**Response to Regulatory Comments
for
Final Focused Feasibility Study/TI Waiver for MARBO Groundwater
Andersen Air Force Base, Guam**

Item	Page	Section	Comments	Response to Comments
Comments provided by EPA Region IX RPM (M Ripperda) in 7/24/08 email				
Focused Feasibility Study Comments				
1	4, last bullet		Please avoid phrases like “conditions are far too toxic...” Either explain the geochemical problems or delete this sentence. Likely “conditions are not favorable” is better	The last bullet point in section 3.0, page 5 now reads “Groundwater geochemical conditions are <i>not favorable</i> for biological reductive dehalogenation.”
2		2	Please include a short description of island groundwater lenses, particularly vertical chloride gradients and the transition zone. A more detailed explanation also needs to go in the TI Waiver Justification, Section 7. as part of the conceptual site model	An additional bullet point was added to section 2.0, page 3 to provide additional description of freshwater lenses. Cross-sectional diagrams illustrating the relationship between lens thickness, time, chloride concentration, and contaminant concentrations were incorporated. (Figures 3 and 5)

*

**ATTACHMENT 1: WELL GRAPHS OF CONTAMINANT
CONCENTRATION VERSUS TIME FOR SHALLOW AND DEEP
WELLS IN THE VICINITY OF TCE AND PCE OCCURRENCES**

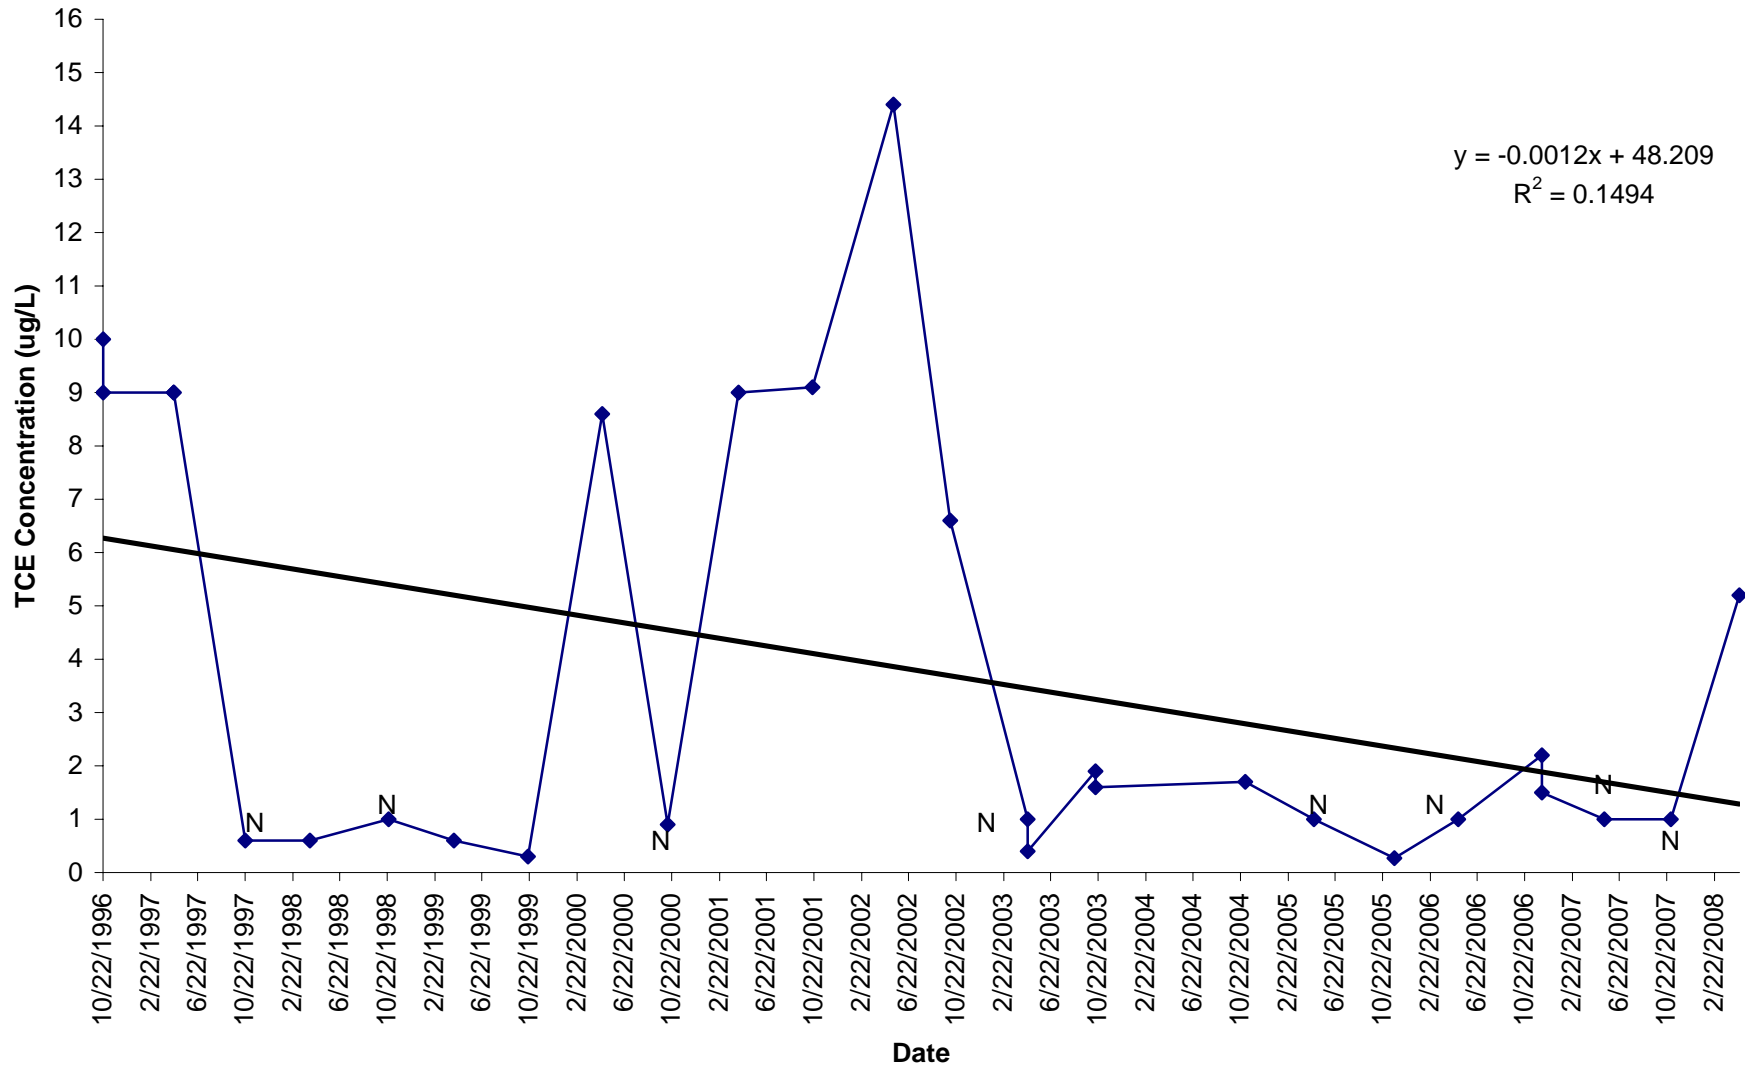
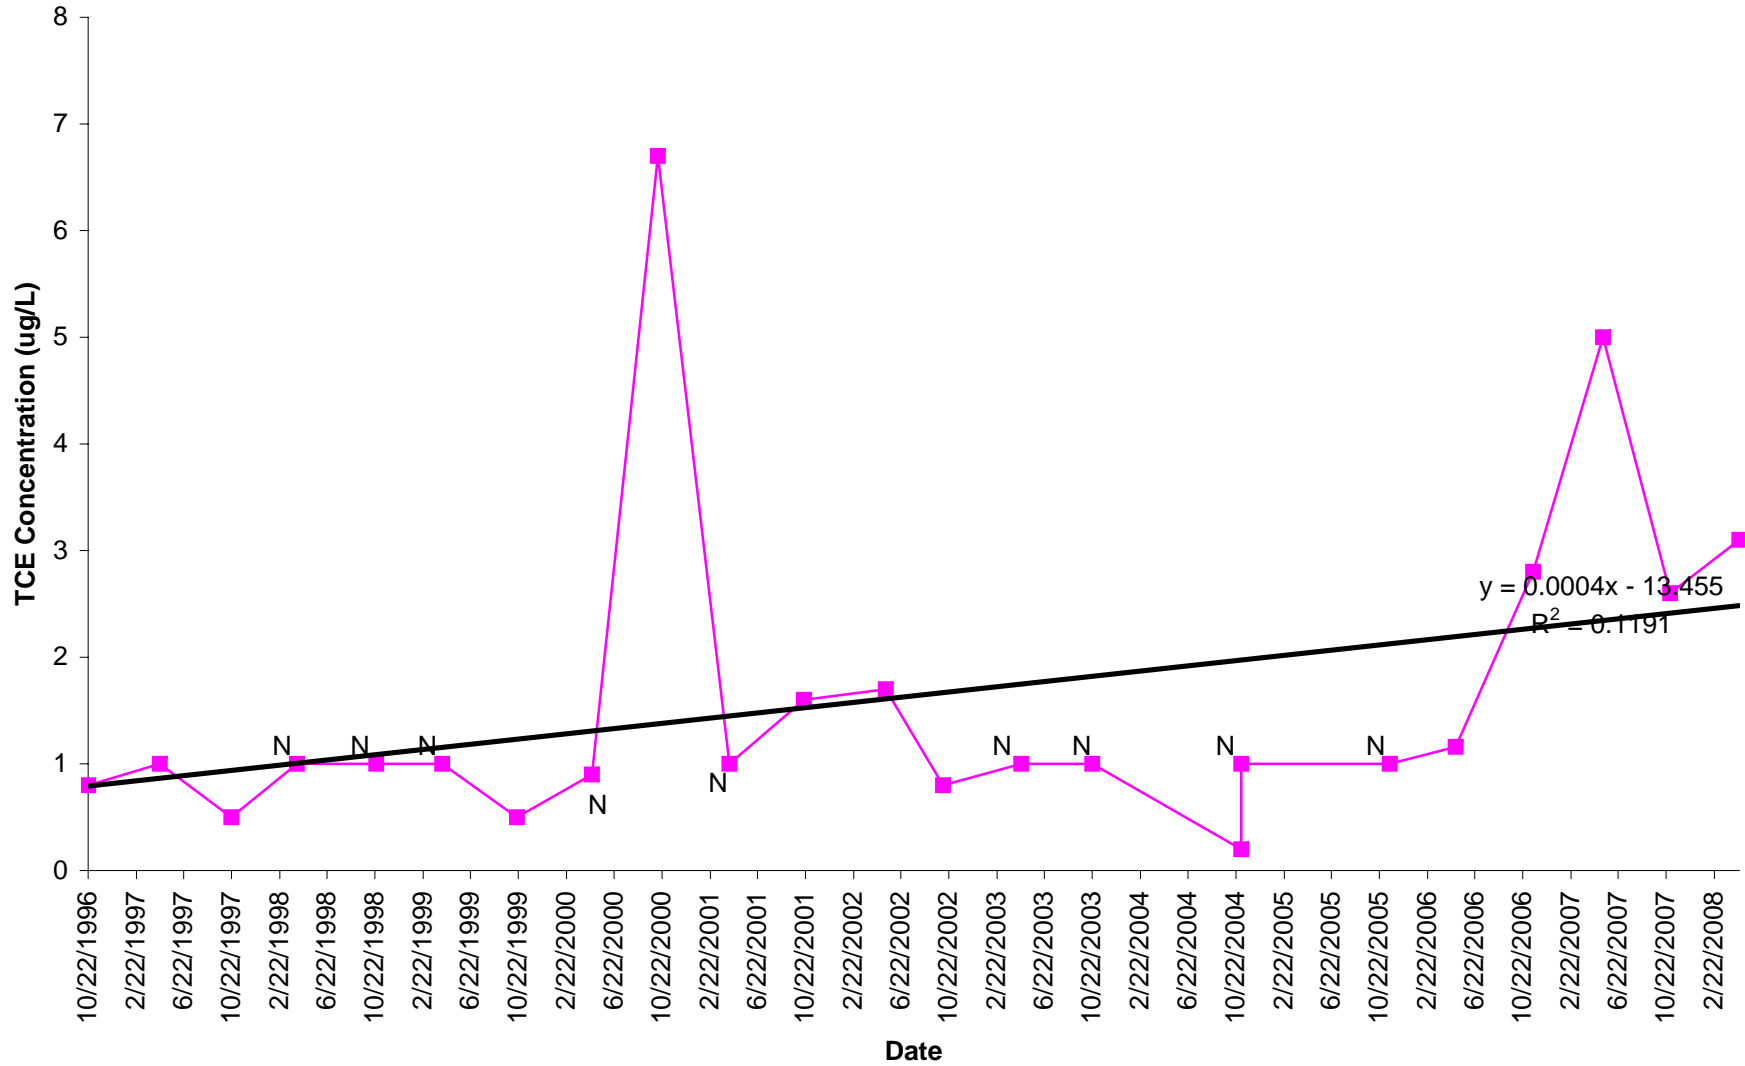
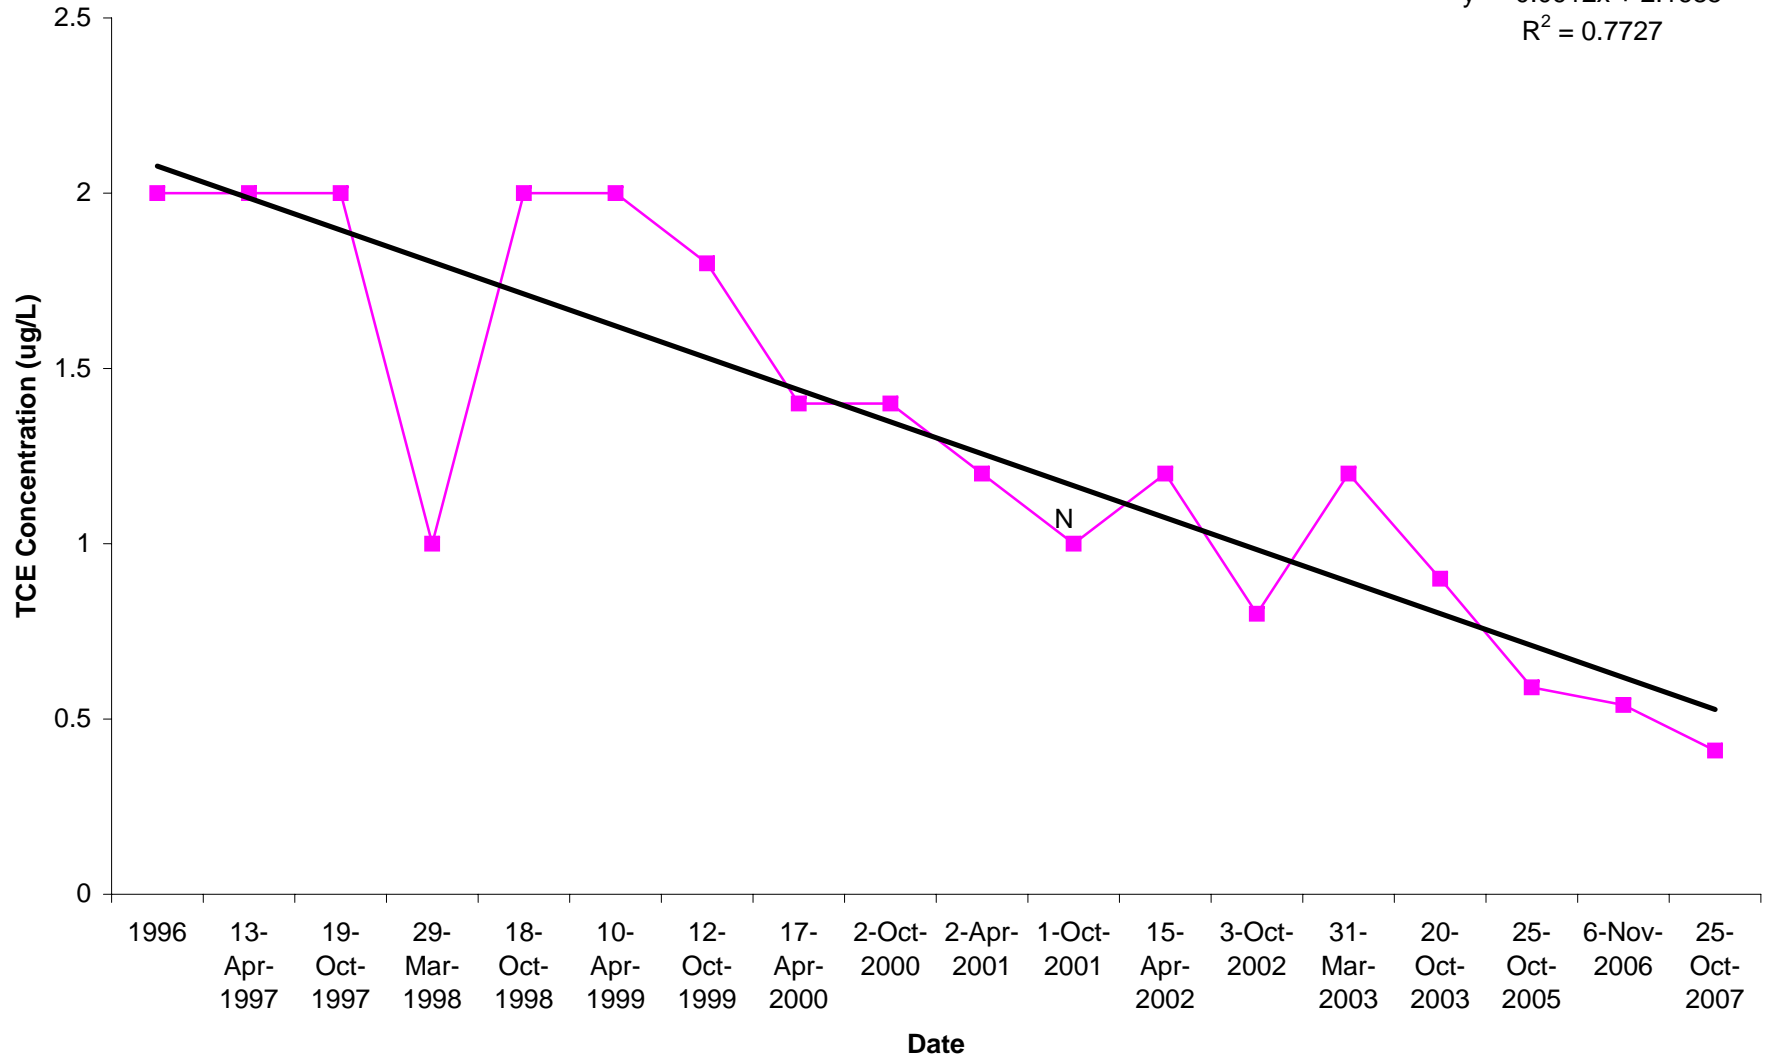
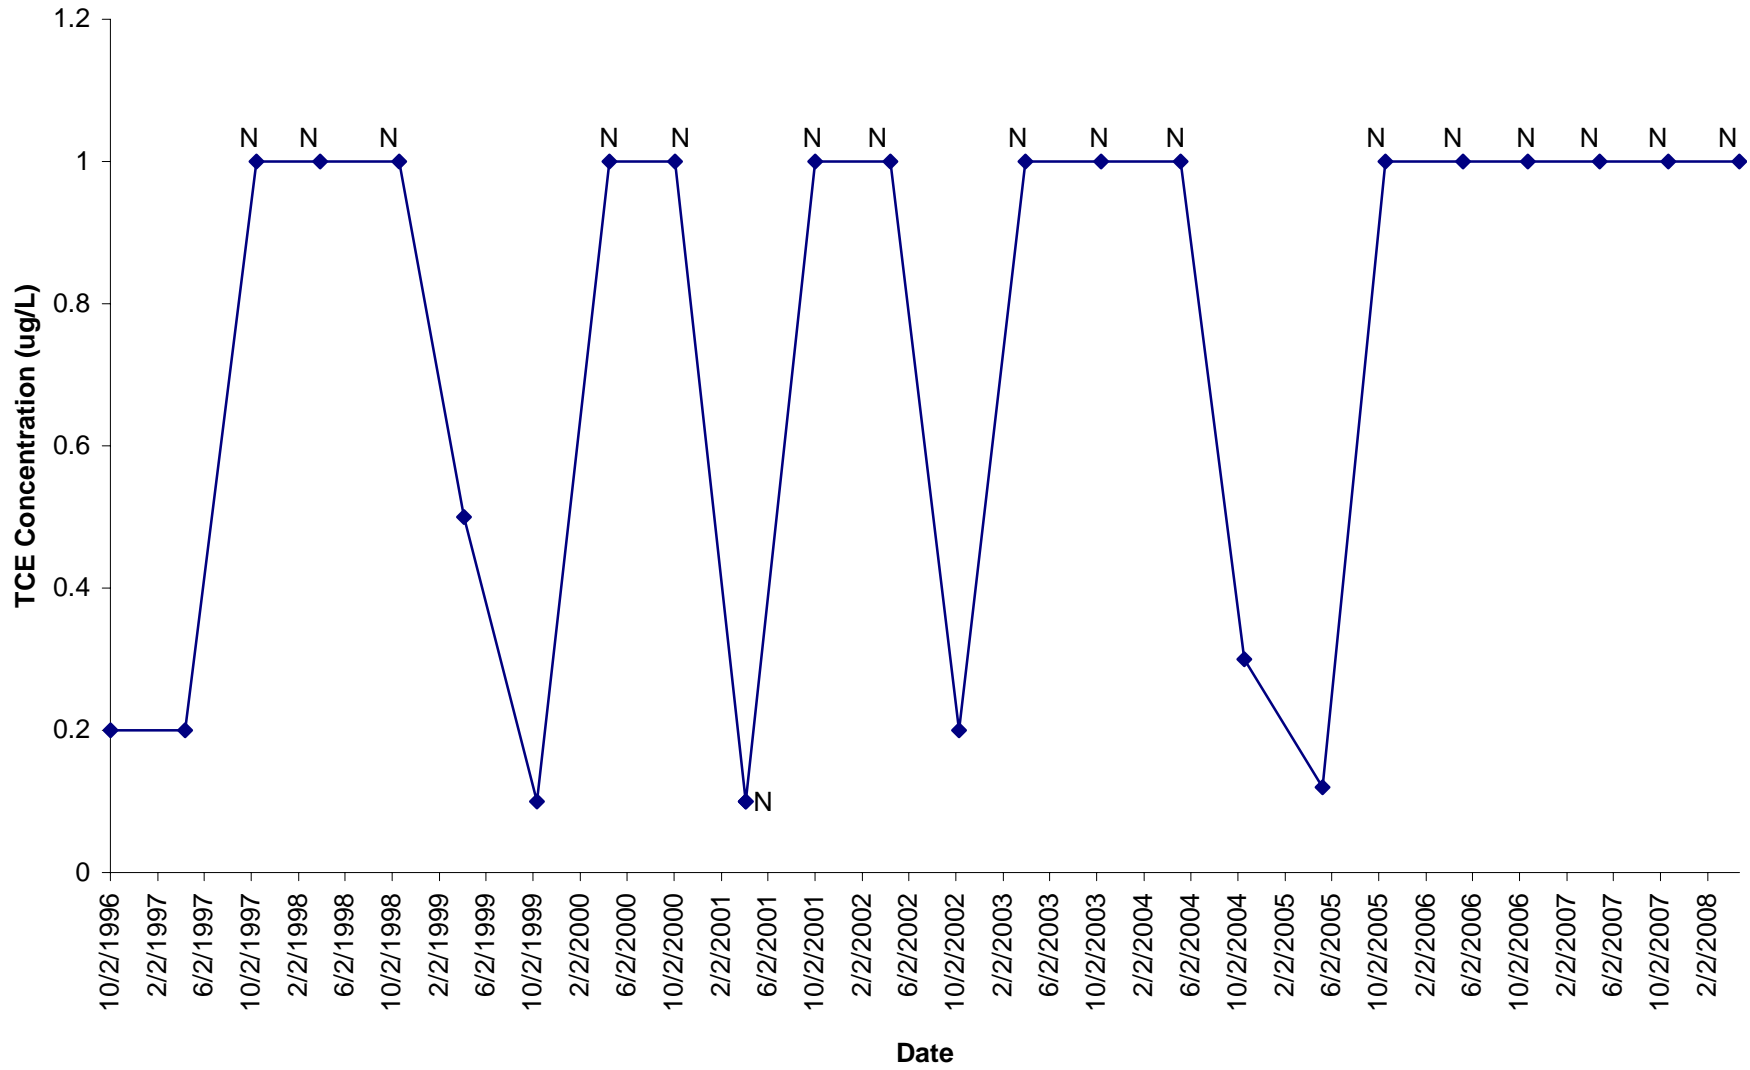
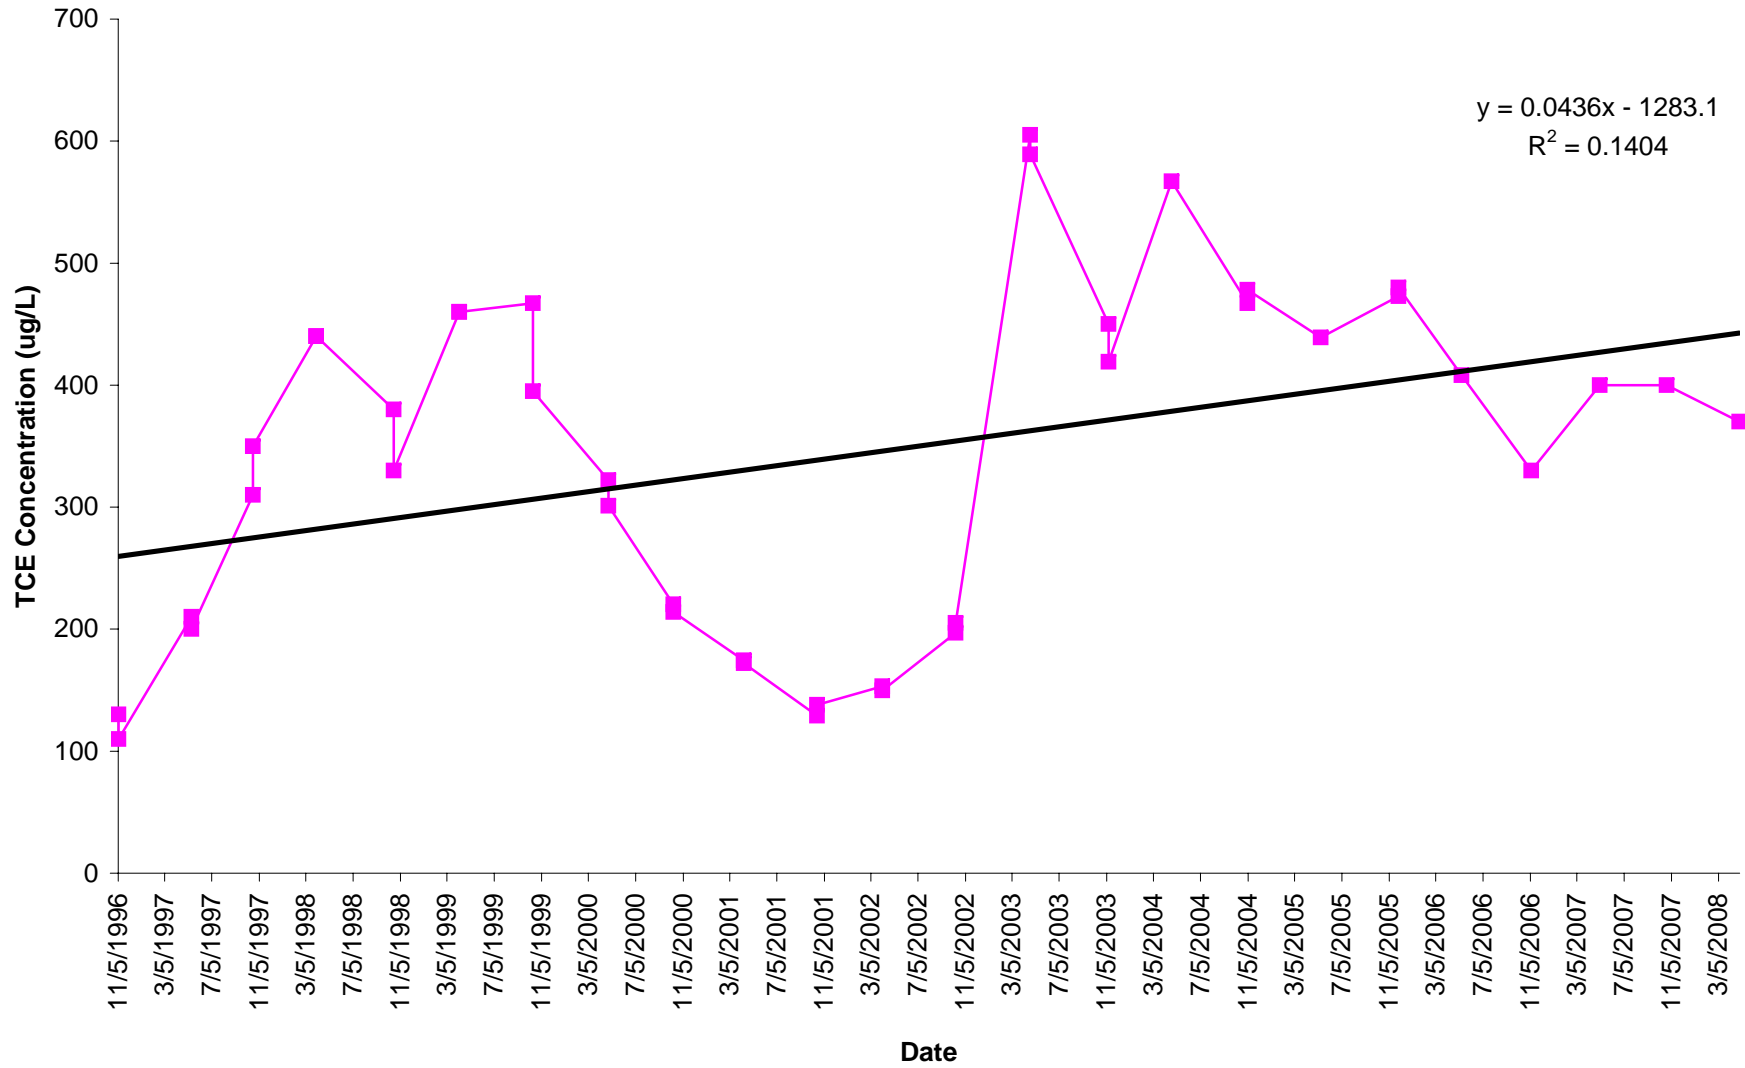
18		Figures	Please add concentration versus time graphs for the deep wells and any key shallow monitoring wells and production wells.	Attachment 1 contains well graphs of contaminant concentration versus time for shallow and deep wells in the vicinity of the TCE and PCE occurrences. Reference to Attachment 1 was made in the second paragraph of Section 8.1.
19		Figure 8	does not show the TI zone..should be depicted here and in cross-section	Acknowledged. Figure 8 was corrected to indicate spatial limits of TI waiver and is now entitled Figure 8-1. Additionally a cross section was added (Figure 10-1).
